MODIFICATION RECOMMENDED

N5225A-02

N5225A PNA Series Microwave Network Analyzers

Some analyzers are exhibiting unlocked or unleveled errors or other unexpected digital control faults. Analyzers that experience any of the symptoms listed on page 2 of this document must be inspected for a possible return to Agilent to have the system motherboard replaced.

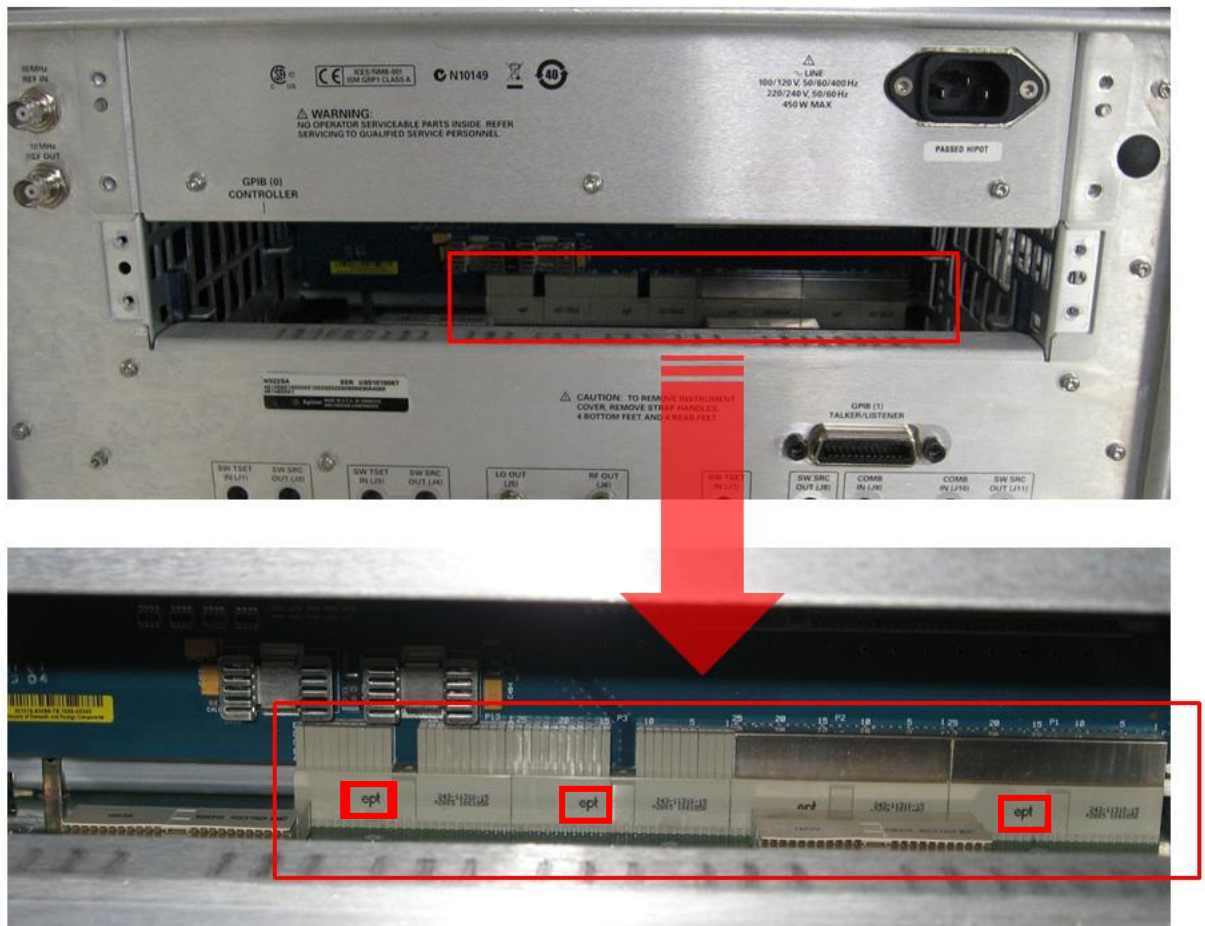
1. Remove the CPU assembly from the analyzer's rear panel. Refer to the PNA Service Guide chapter 7 section titled, "Removing and Replacing the CPU Board Assembly" for removal and reinstallation procedures. To view the online Service Guide, see the numbered list on the next page for instructions.
2. As per the photo below, inspect the system motherboard connector to see if it has one or more "ept" logos.

3. If the connector has one or more “ept” logos, return the analyzer to Agilent for replacement of the system motherboard. If the connector does not have one or more “ept” logos, email support_ctd-soco_support@agilent.com, providing the analyzer model and serial number and details of the malfunction symptoms.
